Mullinckrodt 7/2/60
 Proj. 5-8
 Doc 70-36

3/2 Ref Dwg 6448 and 6574 (3/2 request in green)

6448 (see SG)

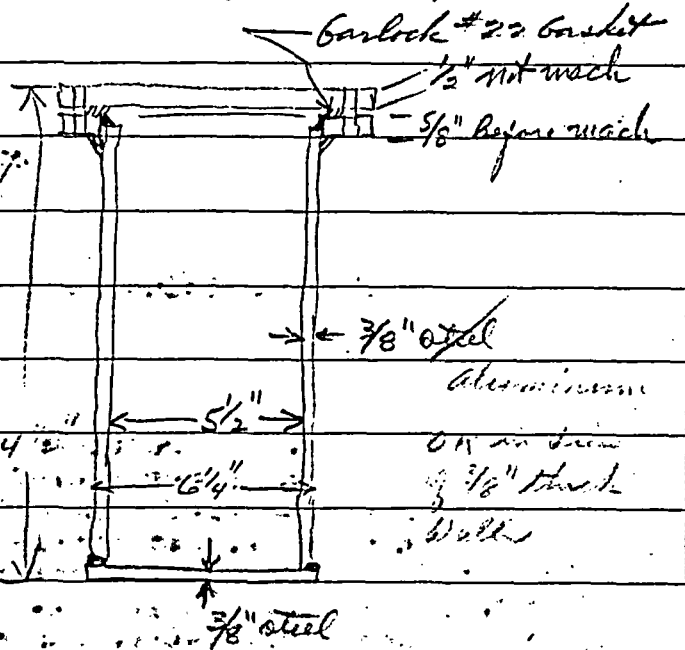
Barlock #22 basket
 1/2" not mach
 5/8" before mach

3/8" oval
 aluminum
 OR in diam
 3/8" thick
 Wall

5 1/2"
 6 1/4"
 3/8" steel

#6448

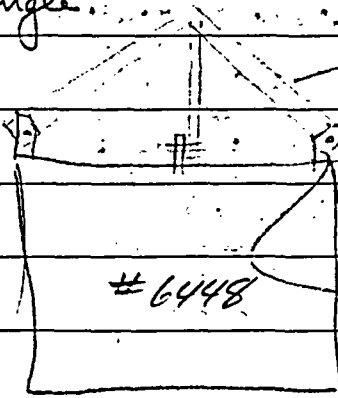
Birdcage main members
 are 1 1/2" x 1 1/2" x 1/4" or
 1 1/2" x 1 1/2" x 3/16" alium
 angle.

3/16" x 1/2" flat
 to prevent
 stacking when
 required
 large permit
 stacking when
 allowed

Pieces - iron Fig 12, PF-17, R-1380
 eg. 8" dia, 15.5/2.3 = 6.73 kg x safe
 Note - full env. metal only. (Q)

May 12 count, single ...
 P = 1.59 kg / ft ...

May in shift 11 x 12 - 132 kg.
 COMPOUND INSULATION
 5" dia dia to can stack.

May of 12 count in shipment
 stacking permitted!

Compound 1 + 2 only - (P > 2.2)
 Side hole corrected by density
 (TID-7019, Sec 2.2, 4/1/60)
 NO stacking (see above)
